MIL-P-60504A(MU)
AMENDMENT 6
24 August 1973
SUPERSEDING
AMENDMENT 5
8 September 1972

MILITARY SPECIFICATION

PRINTED CIRCUIT BOARD ASSEMBLY Q-SWITCH TIMING CIRCUIT: 10541270

This amendment forms a part of Military Specification MIL-P-60504A(MU), dated 18 June 1970.

FIGURE 2

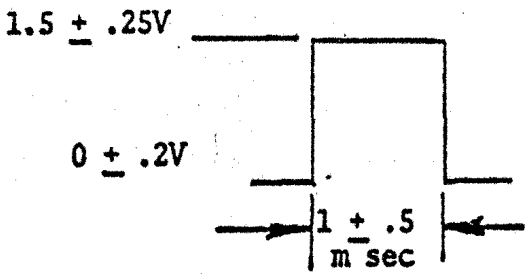
Sheet 15 Figure 2 and 3; Delete and substitute New Figure 2 and 3.

Paragraph 4.6.2.1 Change "Figure 3-1" to "Figure 2".

FIGURE 3

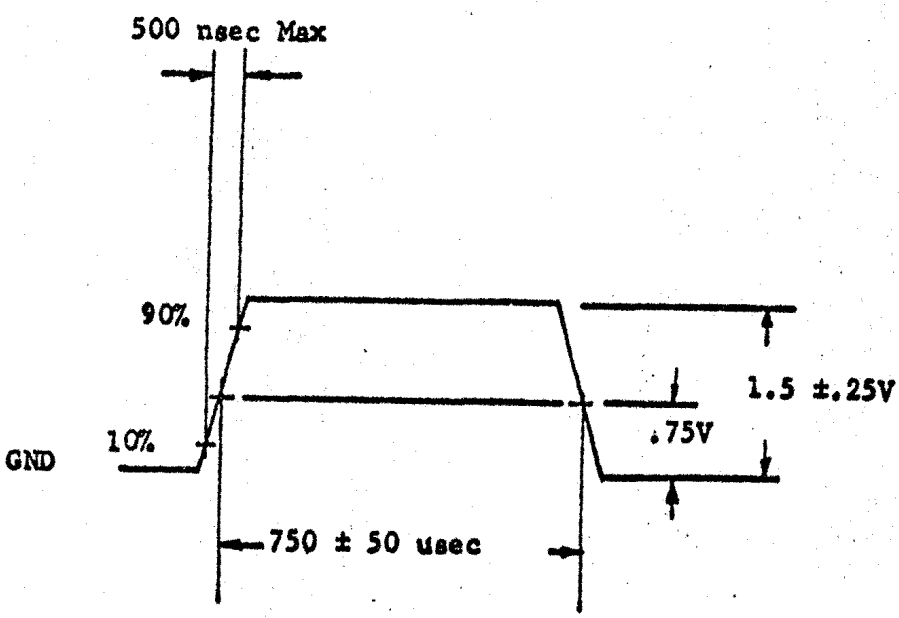
Figure 3: Change "1.5 ± 0.25V" to "1.3V ± 0.25V"; change "750 ± 50 u sec" to "450 u sec minimum"; change ".75V" to "half amplitude".
